ADDENDUM NUMBER ONE (1)

Issuance Date: August 23, 2019
Project Name: LSU School of Veterinary Medicine - Stephenson Veterinary Hospital
Architect's Job No.: 1136.00-17
State Project No: 19-601-17-03
WBS No. F.19002122

ADDENDUM NO. 1 – July 23, 2019

Addendum Number One (01)
August 22, 2019

PLANNING DETAILS **\$410**

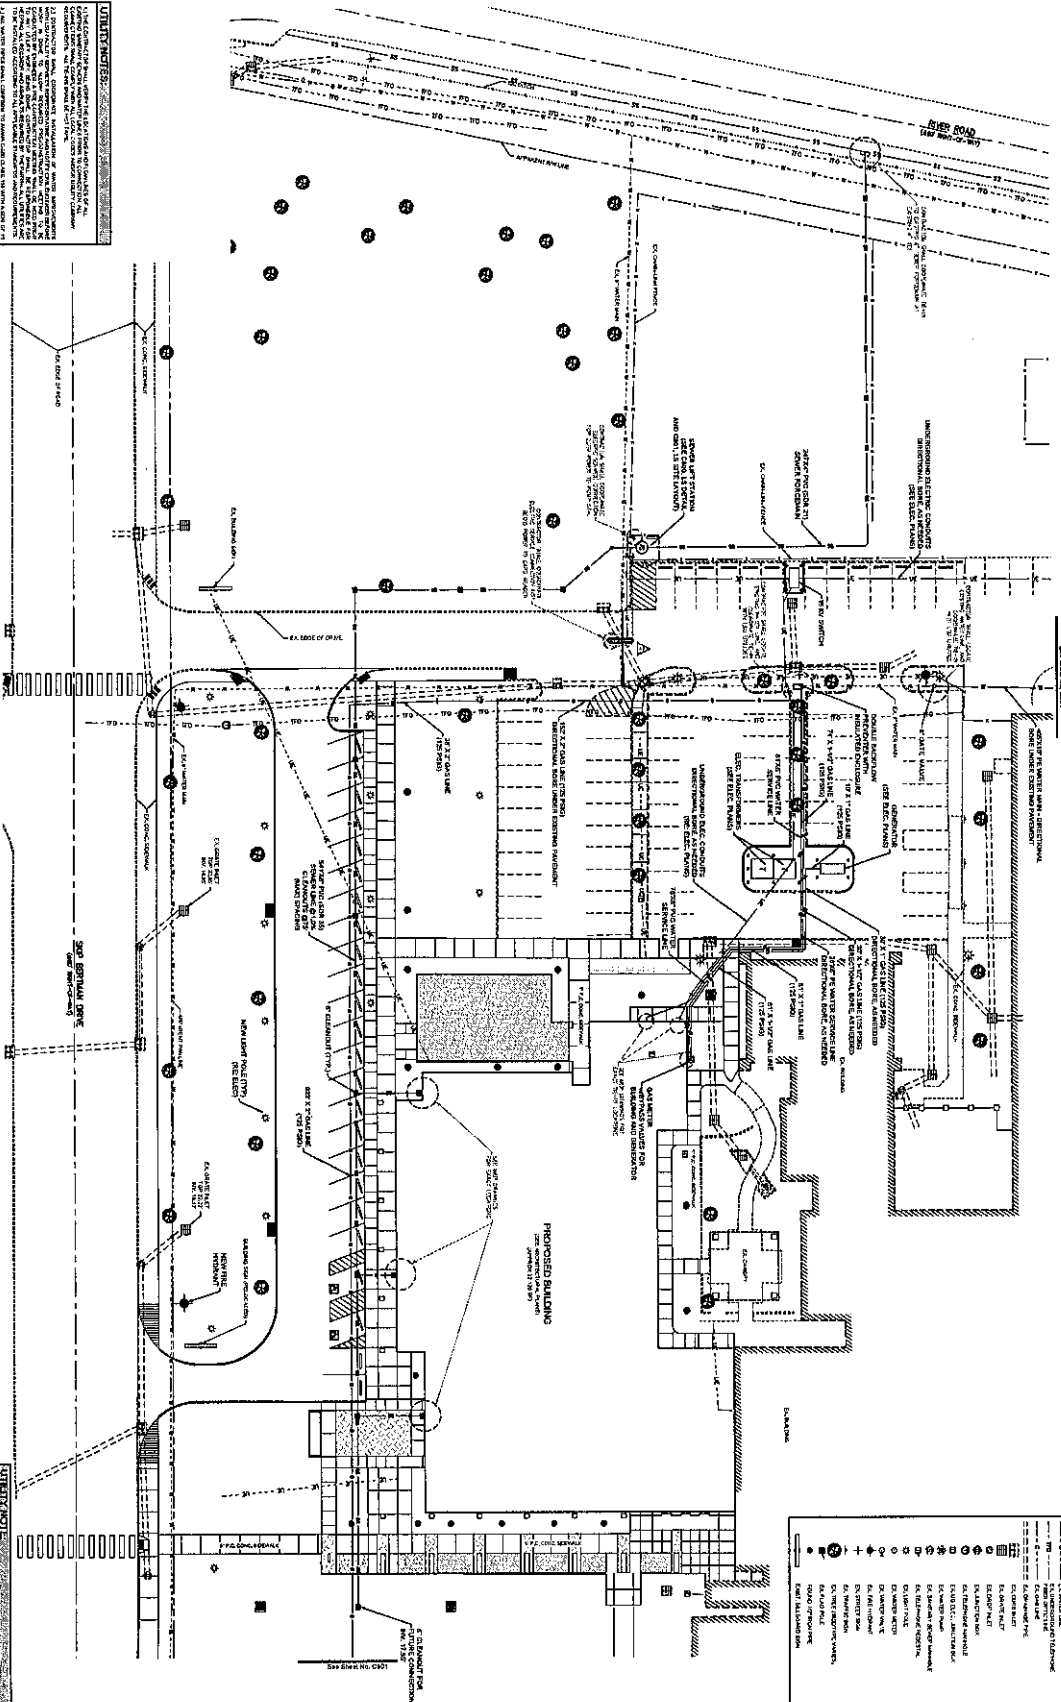
- **Sheet S410 – Framing Details:** Keynotes 22, 23, and 24 have been revised.
- **Sheet C500 – Utility Layout:** Electrical service to card reader at vehicular gates revised.
